**Pre-Submittal Meeting Between NRC and
Exelon for Planned License Amendment
Request to Modify Technical Specification
3.6.1.3 Surveillance Requirement 3.6.1.3**

Figure 1 Current lineup

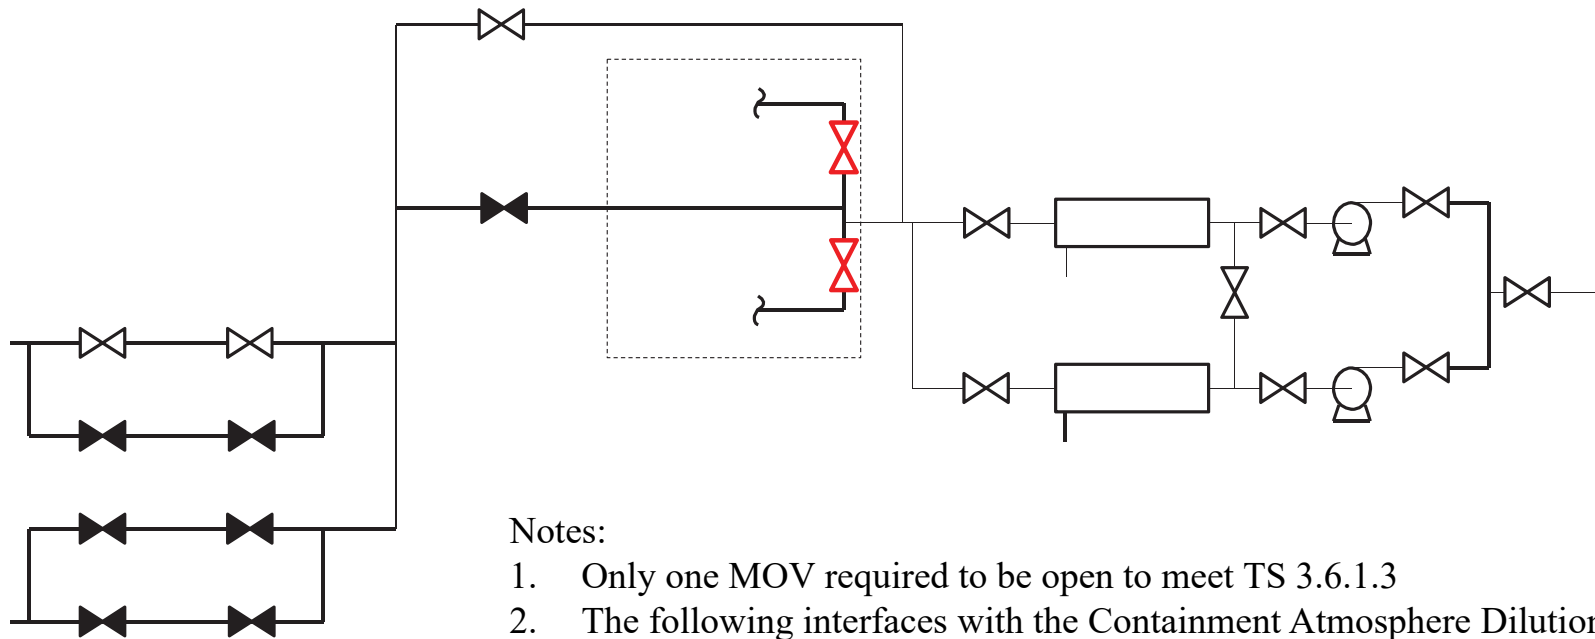
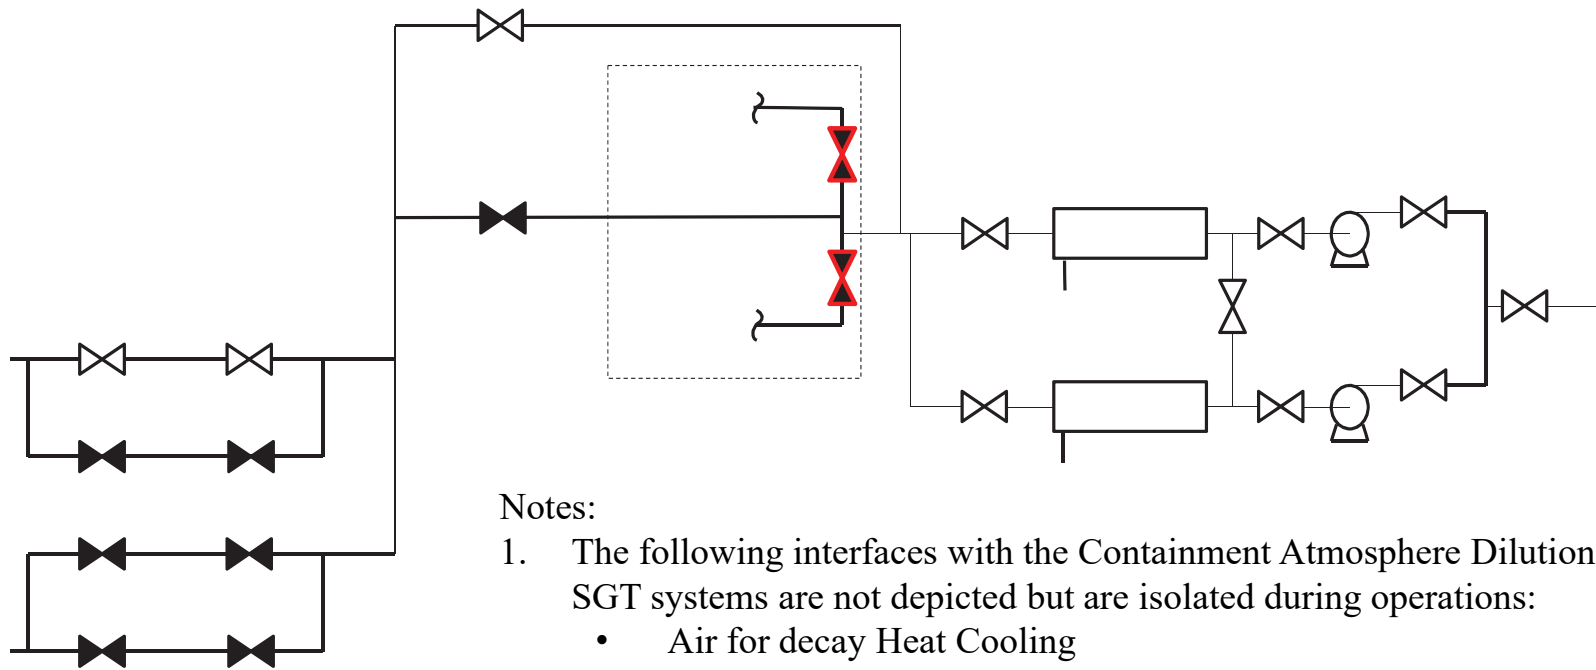
- The proposed change is to continue to align the containment vent path through the 6-inch pathway but close the SGT reactor building suction valves.

- To maintain design basis functions of the SGT System, the design basis calculation of record evaluated that the SGT System can withstand the LOCA-induced loads during the brief periods of containment venting.
- The calculation includes the following cases:
 - Case 1 evaluates the current operating valve lineup at the time a LOCA is postulated to occur. See Figure 1.
 - Case 2 evaluates the proposed valve line lineup at the time a LOCA occurs See Figure 2.

Not required to be met when the 20 inch and 24 inch primary containment vent and purge valves are open for inerting, de-inerting, pressure control, ALARA or air quality considerations for personnel entry, or Surveillances that require the valves to be open, provided the full flow line to the Standby Gas Treatment (SGT) System is closed.”
